Factory Five Racing, Inc.

## 818 Kit

### Assembly manual revision 1M update

### Fuel tank components

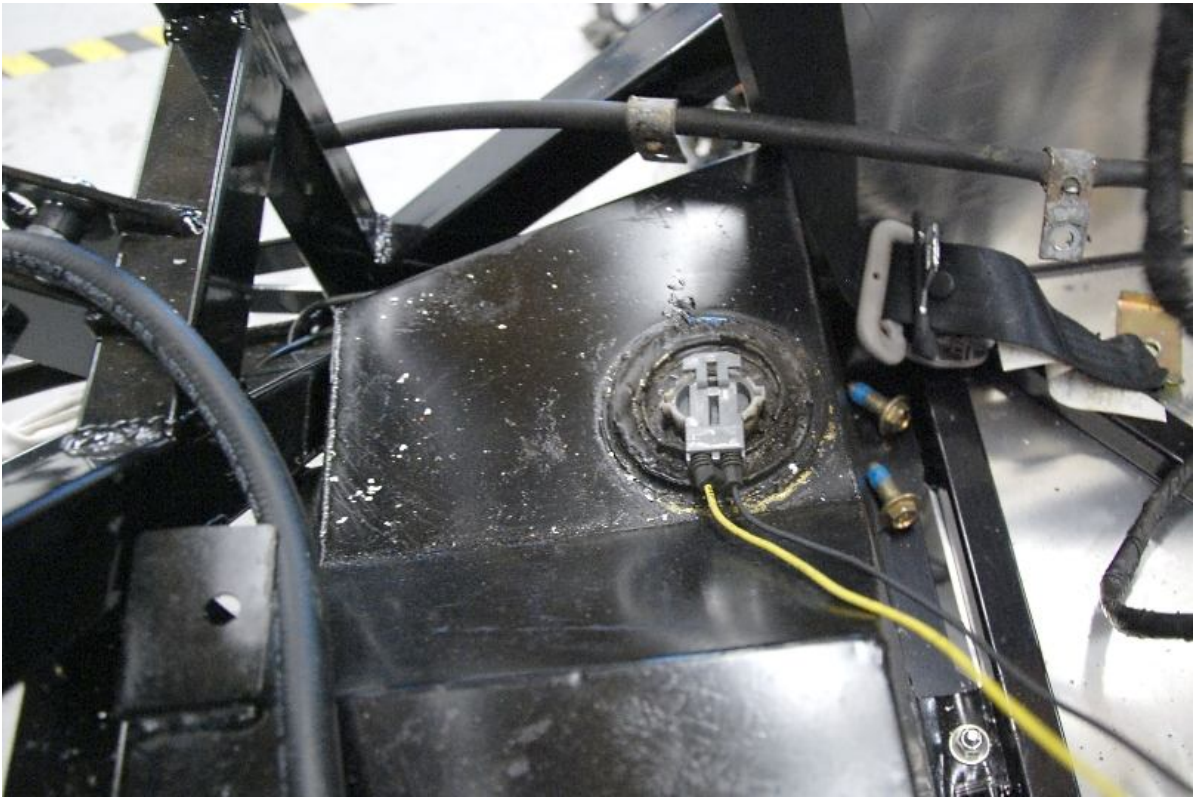
Splice the provided fuel pump plug into the harness in place of the Subaru plug. If you did not mark it on disassembly you can use the top of the sending unit plate to locate the correct plug and wire locations.

The Subaru used two fuel level senders. In order to work correctly one of the sender wires is not used and the two wires must be connected together using solder and tape.

Splice the fuel level sender into the factory harness in place of the old Subaru unit.
